PERFORMANCE  
SPECIFICATION

Drawn	Simon Ng	30 Mar 2007	Scale: 1 : 1	Reference: 14.2068
	Approved.	EDWARD TAN	30 Mar 2007	Title	
The copyright of this drawing is reserved by HELLERMANN TYTON. It is issued on condition that it is not reproduced, copied or disclosed to a third party, either wholly or in part, without the consent of HELLERMANN TYTON.					T120I ②
545, Yishun Industrial Park A Yishun Avenue 7 Singapore 768741 Tel: (+65) 6852 8585 Fax: (+65) 6756 6798			Drawing-No [SG07015-05]		Format A4
			19-0204-001-CSH ⑤		Sheet 1 of 1

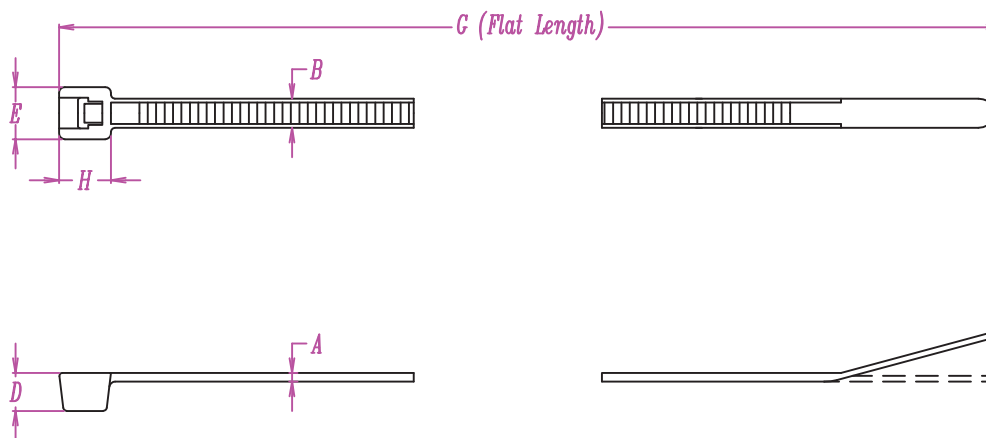
Revision Level		Revision Record	Changed	Date	Approval	Date
Part	Drawing					
	①	Drawing update. Bundle 75 was 80mm. Add (H) indentation.	Mandy Ong	20-July-07	Edward Tan	20-July-07
	②	Remove (H) indentation.	SIMON NG	09-June-15	Edward Tan	09-June-15
	③	Change tie thickness from 1.2 to 1.6mm.	SIMON NG	13-June-17	Edward Tan	13-June-17
	④	Updated Max Bundle from $\varnothing 75$ to $\varnothing 80$ mm base on HT Group standard.	SIMON NG	26-Sep-18	Edward Tan	26-Sep-18
	⑤	Updated pictogramme and drawing template.	SIMON NG	08-Mar-18	Edward Tan	08-Mar-18
	⑥	Added HT Global project Number.	SIMON NG	08-Mar-18	Edward Tan	08-Mar-18

③ A	B	D	E	G	H
1.6 $\pm 0.2$	7.6 $\pm 0.2$	7.7 $\pm 0.6$	13.0 $\pm 0.9$	300.0 $\pm 5.0$	10.2 $\pm 1.0$

Bundle  $\varnothing$  Max.  
5 ~ 80mm ① ④
